Monks Orchard Residents' Association Planning

20th June 2022

Reference: 22/02015/FUL
Application Received: Sat 14 May 2022
Application Validated: Mon 16 May 2022
Address: 44 Orchard Avenue Croydon CR0 7NA
Proposal: Demolition of an existing detached dwelling and construction of a new three storey building comprising 7 apartments with associated private and communal amenity space, refuse and cycle storage.
Status: Awaiting decision
Consultation Expiry: Fri 01 Jul 2022
Determination: Mon 11 Jul 2022
Case Officer: Jeni Cowan

Please accept this letter as a formal objection to **Application Ref: 22/02015/FUL** for Demolition of an existing detached dwelling and construction of a new three storey building comprising 7 apartments with associated private and communal amenity space, refuse and cycle storage at **44 Orchard Avenue Croydon CR0 7NA**.

Design Code Analysis for the various local areas shows all < or within “Outer Suburban” Settings whereas the proposal would require an Urban Setting.

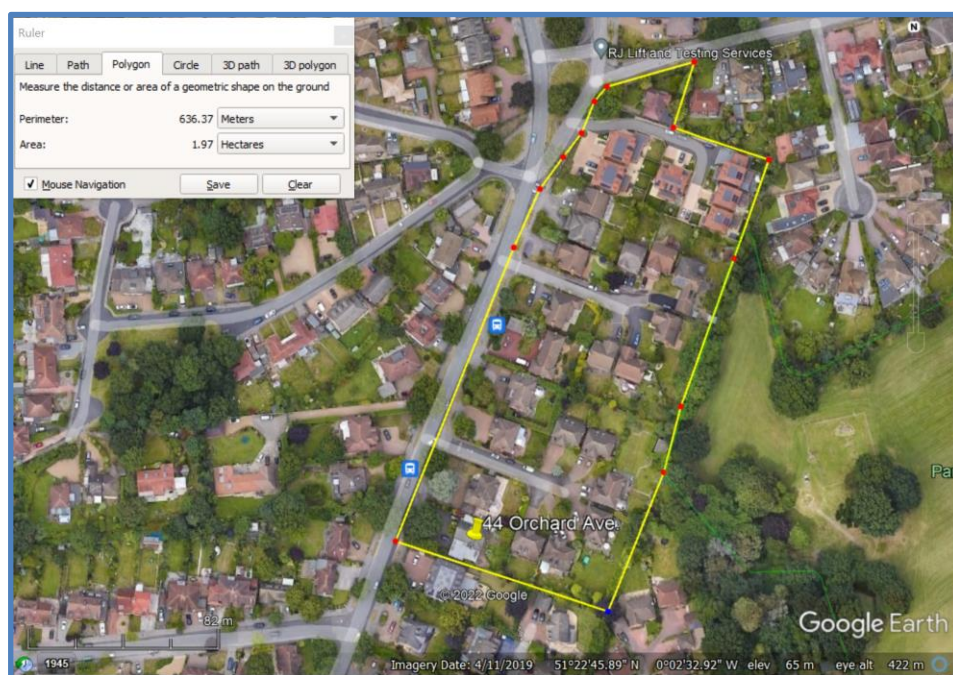
- 5.1.1 Based on the guidance in the National Design Code Part 1 we have assessed the Design Code Densities for the following areas:

Design Code Area	Area (ha)	Population	Dwellings	Housing Density (Units/ha)	Residential Density bs/ha	Setting (as defined by the National Model Design Code)
Shirley North Ward	327.9	15666	6555	19.99	47.78	< Outer Suburban
Shirley South Ward	387.3	14147	5919	15.28	36.53	< Outer Suburban
Shirley	715.2	29814	12474	17.44	41.69	< Outer Suburban
Post Code CR0 7NA	1.97	36	18	9.14	18.27	< Outer Suburban
MORA Area	178.26	9283	3884	21.79	52.07	Outer Suburban
Average for the Locality	322.13	13789	5770	16.73	42.81	< Outer Suburban
44 Orchard Avenue (Proposal)	0.1	21	7	70.00	210.00	Urban
Percentage of proposal above average	(This cannot be considered a moderate or gentle incremental increase)			318.45%	390.58%	This clearly is NOT Moderate or Gentle Intensification!

CRO 7NA Post Code approximate Area at 1.97hectares

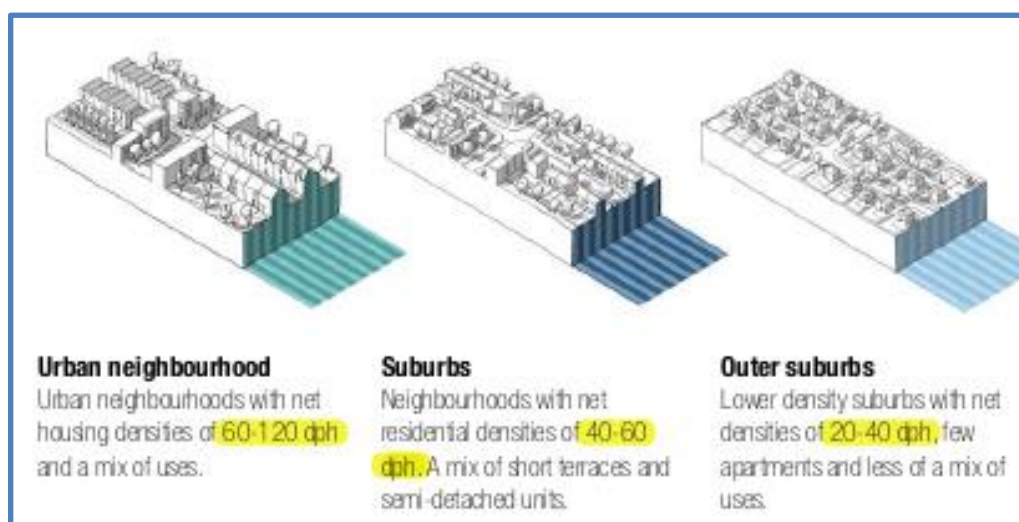
- 5.1.2 In order to evaluate the local Design Code a range of parameters need to be assessed based upon the Local Character. The Post Code approximate Area is defined from Google Earth and Post Code Boundaries from searches on the internet⁶. The number of dwellings are obtained from The Valuation Office Agency⁷.

- 5.1.3 The Post Code Area **CR0 7NA** has a current **population** of **36** Housed in **18 Dwellings** in an approximate Area of **≈1.97hectare** which equates to a **Housing Density** of **9.14Units/ha** and a **Residential Density** of **18.27 persons/ha**. Which places the **Post Code** in an **‘Outer Suburban’ Design Code Setting** as defined by the **National Model Design Code & Guidance**.

The National Design Code Housing Densities appropriate for local Settings as published in the National Model Design Code Part 1.

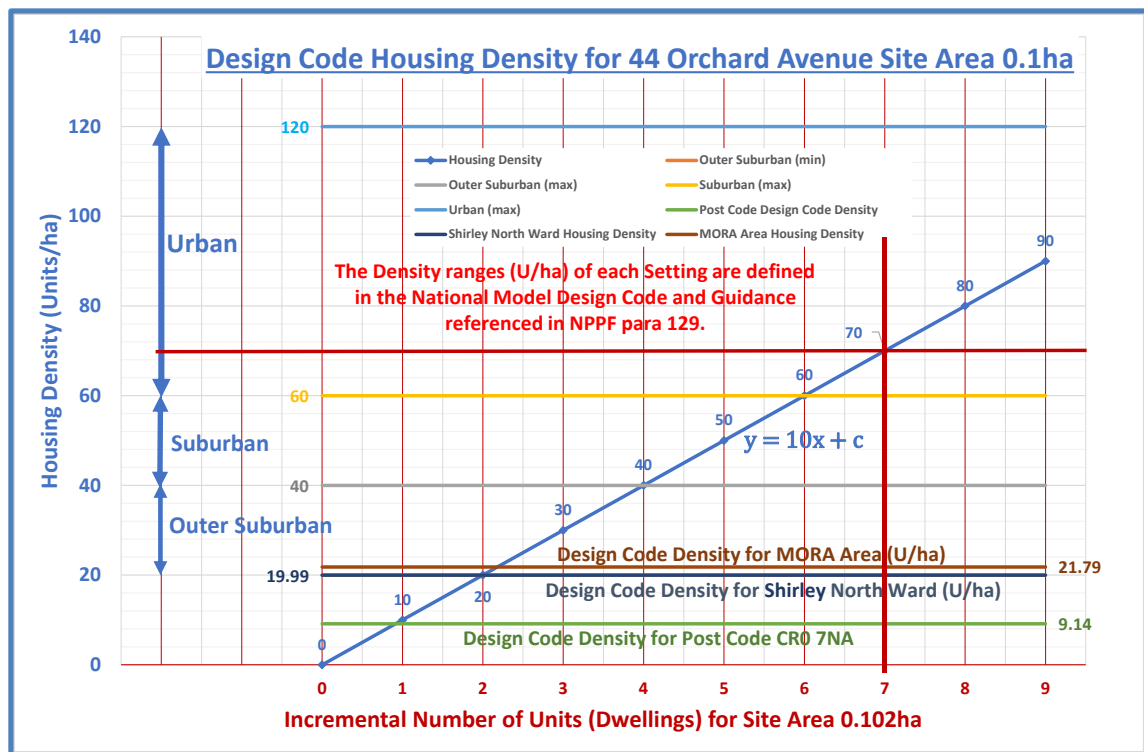
- 5.2.2 **National Model Design Code Part 1 page 14** provides guidance on **Housing Densities** for local **“Settings”**.
- 5.2.3 As the Croydon Local Plan has **NO** guidance on the local **Design Codes** (see **NPPF Para 129** and **Para 5.2.1** above) **“The National Model Design Code & Guidance should be used in the absence of locally produced design guides or Design Codes”**.
- 5.2.4 The graphical illustration below plots the **Design Code Housing Density** (Units/ha) over the range **0 to 9 dwellings** for the **Site Area (0.1ha)** of **44 Orchard Avenue**, against various examples of **Design Codes of the local Areas** to show that the prevailing **Design Code ‘Setting’** for the locality is **well within** the prescribed parameters for **“Outer Suburban” (or Outer London Suburban) Setting**.

- 5.2.5 **Shirley is definitely NOT Urban** as defined in the current adopted **Local Plan**. At 70 Units/ha appropriate for an “Urban” Setting, this proposal is clearly an over development for the localities average Design Code ‘**Outer Suburban**’ Setting.

Suggested limits of Intensification for "Gentle," "Moderate" & "Focussed" for each Area Type or Setting

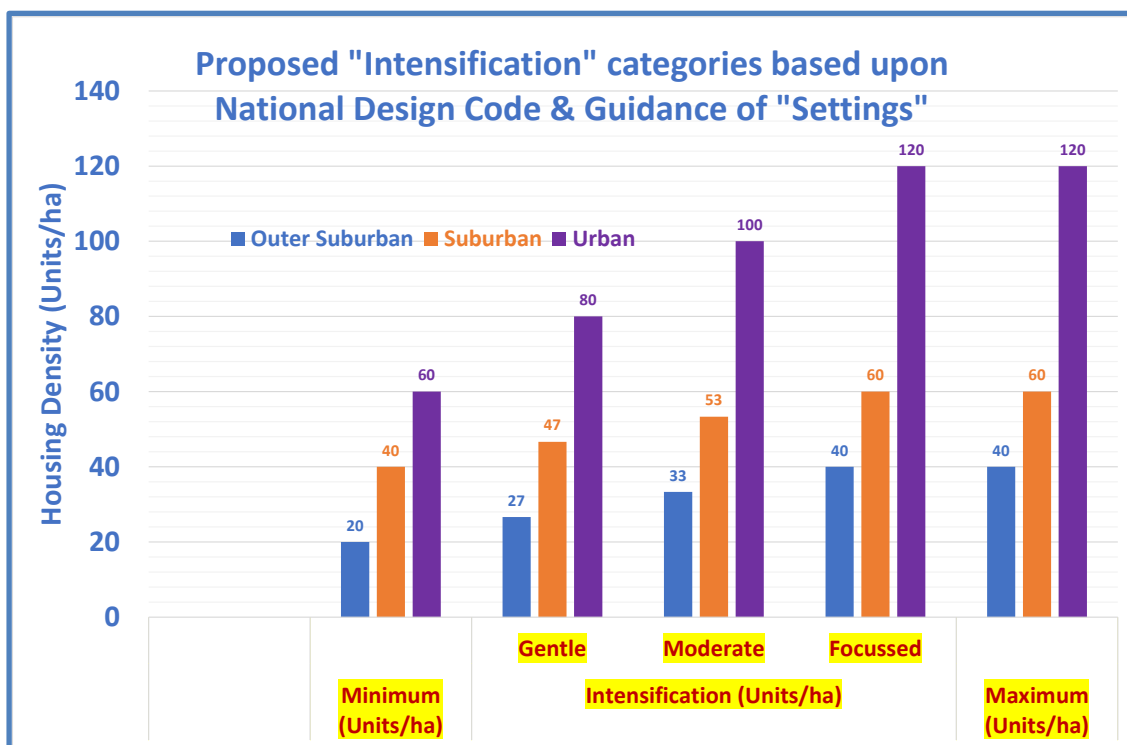
- 5.2.8 We have shown (below) an **incremental** increase in **Design Code Density** of $\frac{1}{3}$ & $\frac{2}{3}$ between Settings for “**Outer Suburban**”, “**Suburban**” and “**Urban**” for “**Gentle**”, “**Moderate**” and “**Focussed**” Intensification or **densification**. There is **NO** equivalent for “**Central**” Area Type setting, as there is **NO** defined maximum. The Maximum Density at “**Central**” Area Types or Settings is defined by the proposal’s requirement to meet the **Minimum Internal Space Standards** and **Private Amenity Standards**.

- 5.2.10 Thus for **44 Orchard Avenue**, the **"Gentle" *Densification*** should **NOT** exceed a **Housing Density >27Units/ha** but it actually reaches **70 Units/ha** which is $(70-27)/27 = 159\%$ increase above the **"Gentle" *densification*** appropriate for the locality to retain **infrastructure sustainability**. This is clear evidence of **excessive overdevelopment** of the locality for the proposed development at **44 Orchard Avenue** for sustainability within the existing supporting infrastructure.

Residential Densities for Site Capacity of 44 Orchard Avenue relating Number of occupants and the equivalent National Model Design Code Settings.

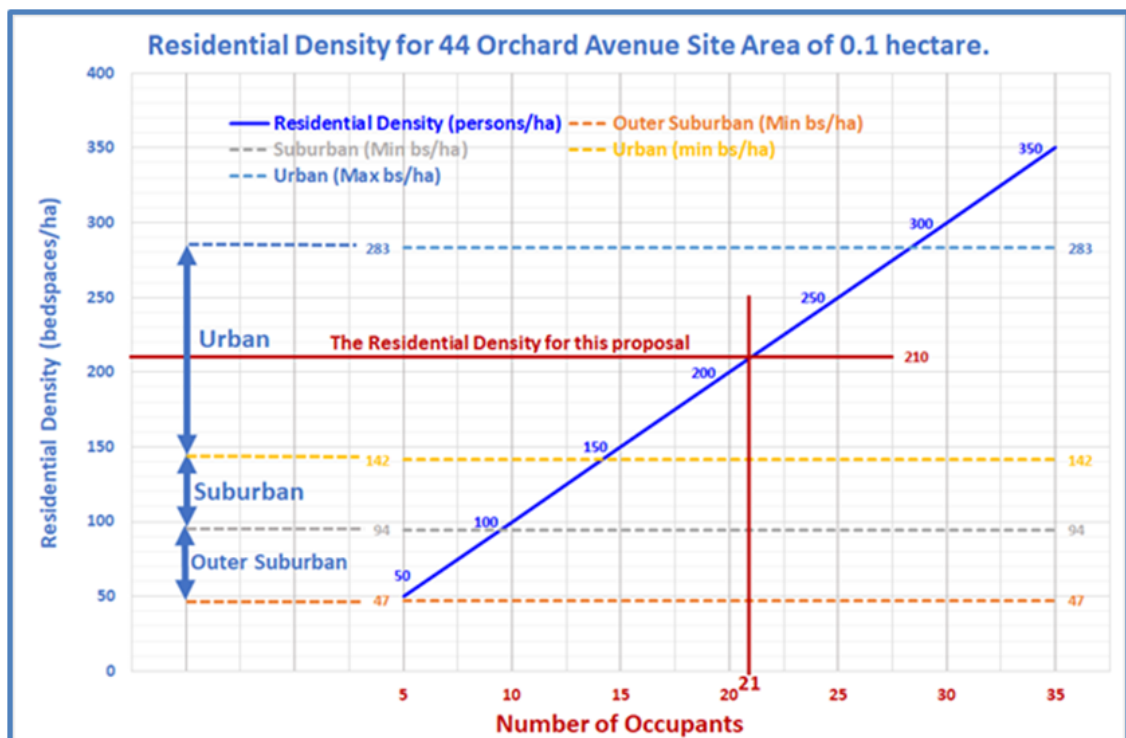
- 7.1 It is people who require supporting infrastructure, **NOT** Dwellings, so we need to establish equivalent **Residential Densities** ranges for the 'Settings'. This can be achieved using the **Office of National Statistic's** data and **Statista**⁸ data. In 2021, the average number of people per household in the United Kingdom was **2.36** compared with 2.37 in the previous year. As the **National Model Design Code** is based on **National Guidance**, we can use this as a **National** factor to convert **Units/ha to the equivalent Bedspaces/ha** as shown in the following **Graphical illustration**.

- 7.2 Using this data, and **TfL Connectivity data**, we can convert **Housing Density** to an average approximate **Residential Density**. However, we can plot and illustrate the required **Settings** for this proposed **Residential Density** in **bedspaces/hectare** which gives an estimated relationship between **Residential Density** and **PTAL** for each of the 'Settings' based upon **National Statistics**.

- 7.3 The evaluation of this proposal places **44 Orchard Avenue** in an **Urban Setting** when **all other assessment of the locality is either less than <Outer Suburban or within the Outer Suburban Settings** with **7 dwellings** at **Housing Density of 70Units/ha** clearly within the mid-range of an 'Urban' 'Setting', whereas **the locality** by the various local **Area evaluations** is well within or even below the **Outer-Suburban Design Code 'Setting'**. Additionally, at a **Residential Density of 210 Bedspaces/ha or 180 hr/ha**, the **Residential Density** confirms the capacity requires an '**Urban**' Setting whereas the actual Setting is '**Outer Suburban**'.
